Providence City Plan Commission

February 18, 2025

AGENDA ITEM 1 ■ 20 ERNEST STREET

Building elevations

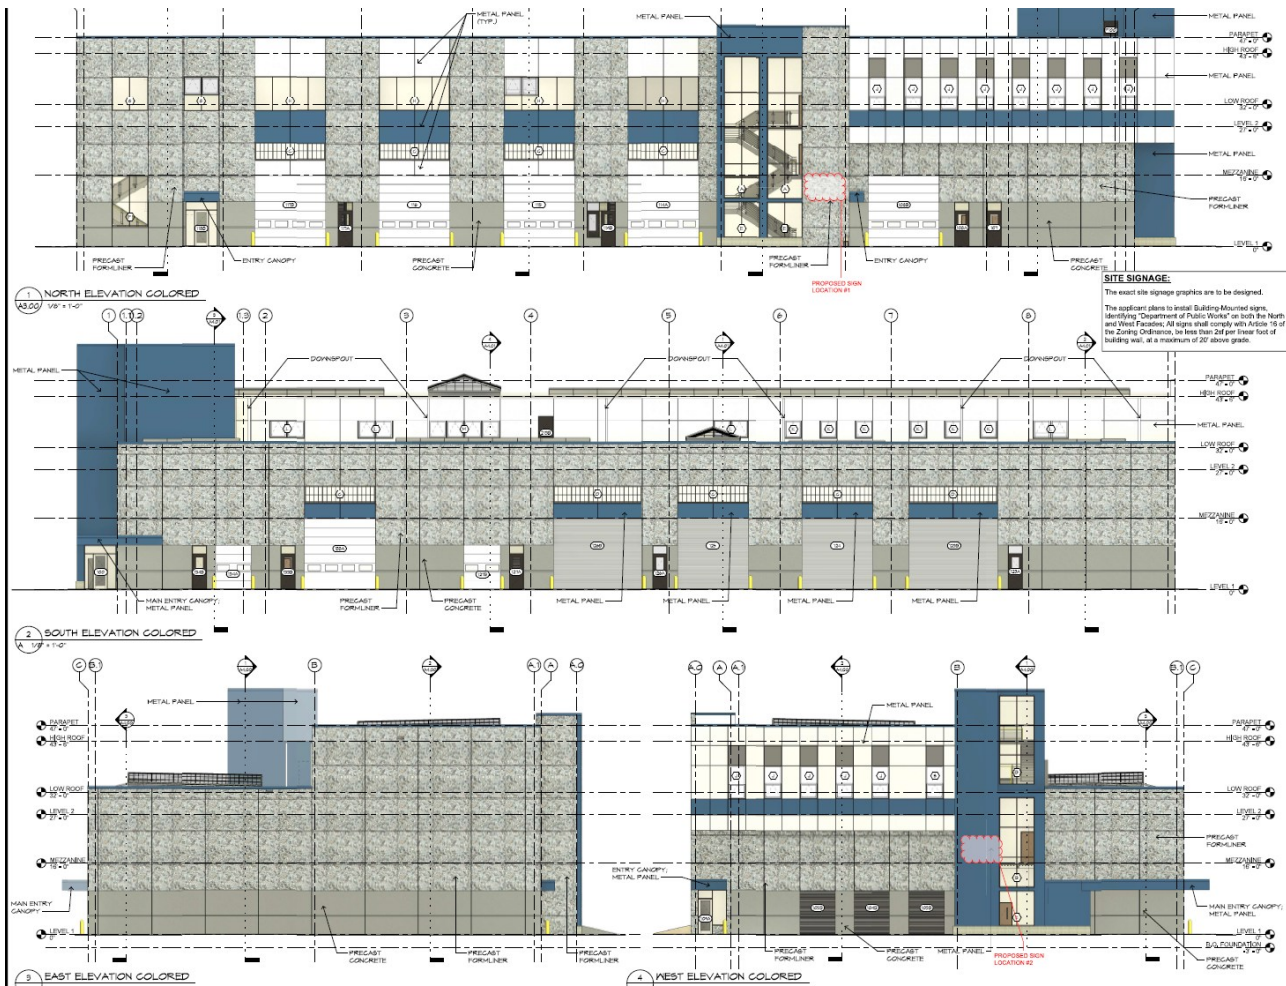
The applicant has requested waivers from submission of a signage plan, photometric plan, and DPW and State stormwater management approvals. Building elevations indicate the proposed signage locations, which will be used to identify the building. The signs are within the allowable area for wall signs, but no designs have been provided. The photometric and stormwater management plans are contingent on finalizing the building's siting. Review of the stormwater management plan requires the action of City and State bodies, which can vary. The DPD recommends that the CPC grant the requested waivers with the condition that the items be submitted at the permitting stage. Granting the waivers would be in the interest of good planning practice as it would allow the applicant to proceed with the review and approval process.
